AMENDMENT OF SOLICITATION/MODIFICATION OF CONTRACT				1. CONTRACT ID CODE	PAGE 1	OF PAGES 3
2. AMENDMENT/MODIFICATION NO. 0001		3. EFFECTIVE DATE 09/09/2026		4. REQUISITION/PURCHASE REQ. NO. 7375939		5. PROJECT NO. (If applicable)

E. IMPORTANT: Contractor ☐ is not ☐ is required to sign this document and return original to the issuing office.						
14. DESCRIPTION OF AMENDMENT/MODIFICATION (Organized by UCF section headings, including solicitation/contract subject matter where feasible.)						
PROJECT XK11237, REPAIR AND UPGRADE BUILDING 4034, Station Marine Corps Air Station Cherry Point, NC The proposed PPI end date of 10 September 2026 by 1400 remains unchanged. The proposal due date of 16 September 2026 by 1500 remains unchanged. The purpose of this amendment is to answer pre-proposal inquiries (PPIs). See attached.						
15A. NAME AND TITLE OF SIGNER (Type or print)				16A. NAME AND TITLE OF CONTRACTING OFFICER (Type or print)		
15B. CONTRACTOR/OFFEROR (Same as Item 8)		15C. DATE SIGNED		16B. UNITED STATES OF AMERICA BY		16C. DATE SIGNED
(Signature of person authorized to sign)				(Signature of Contracting Officer)

U.S. MARINE CORPS AIR STATION
CHERRY POINT, NORTH CAROLINA
RE

WINDOW TYPES

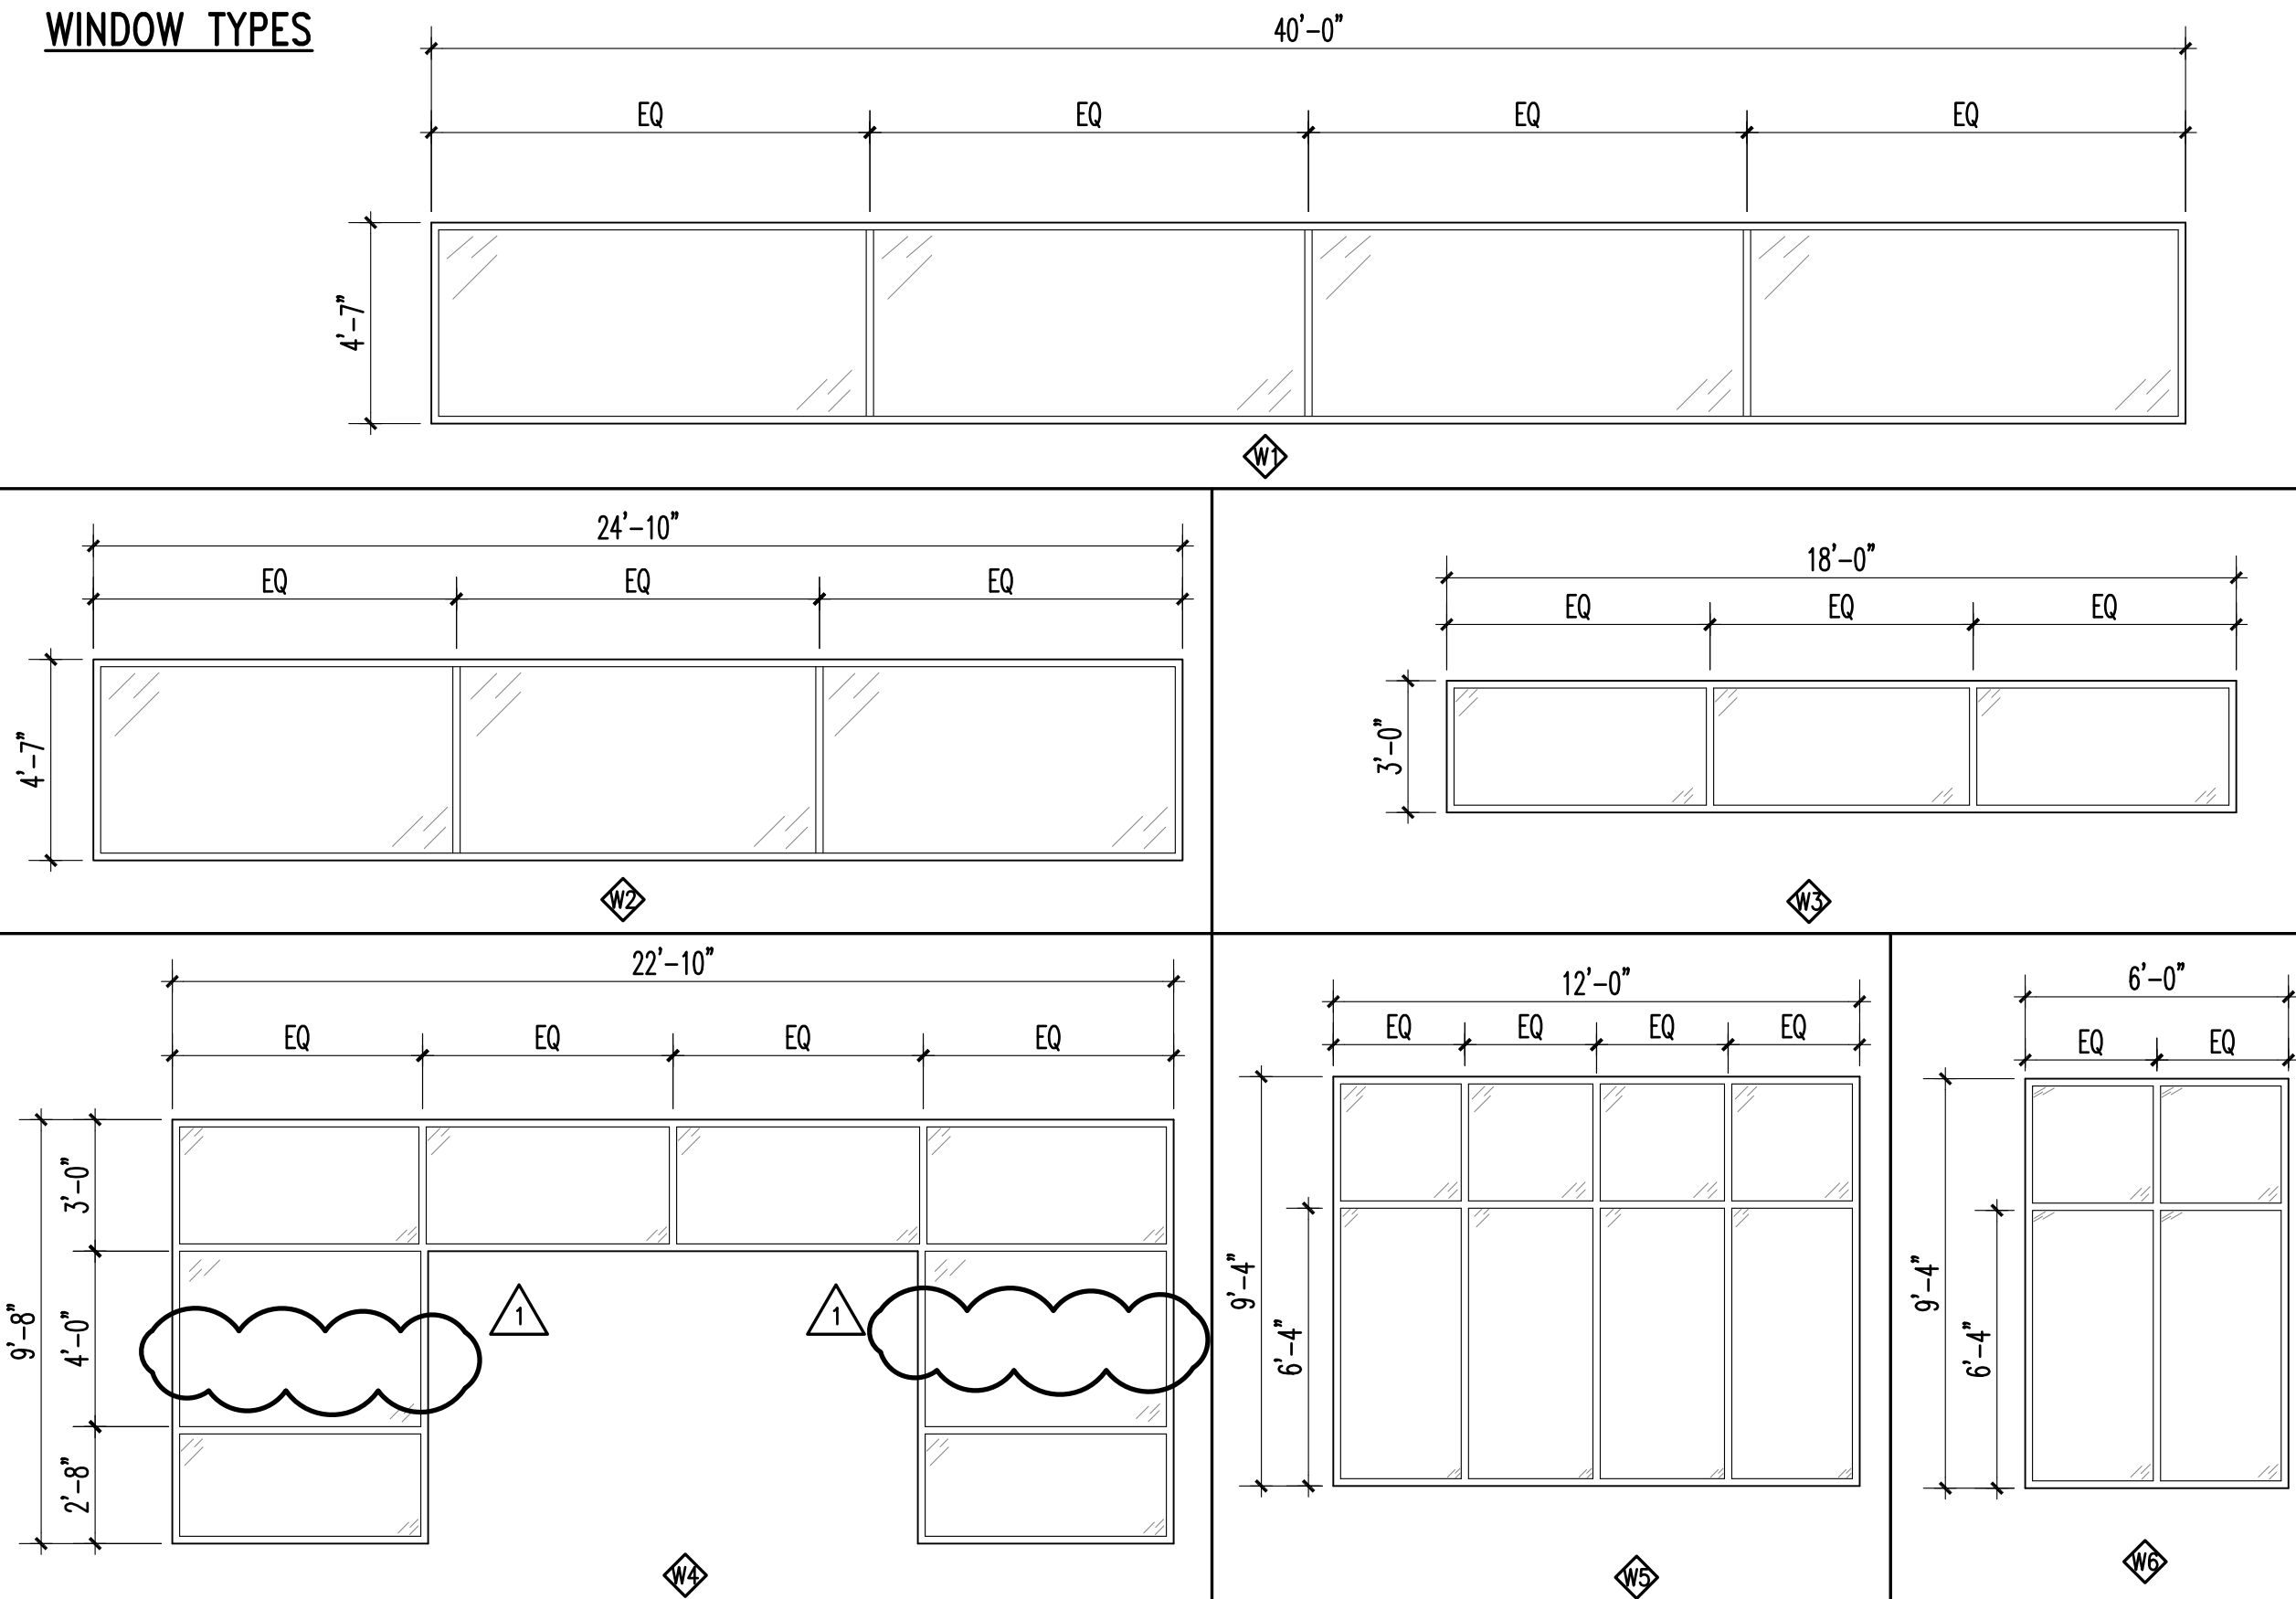
3. Lines generally denote operable. I can't see how or why these openings wouldn't be fixed. Clarification please?

Response: See attached updated drawing
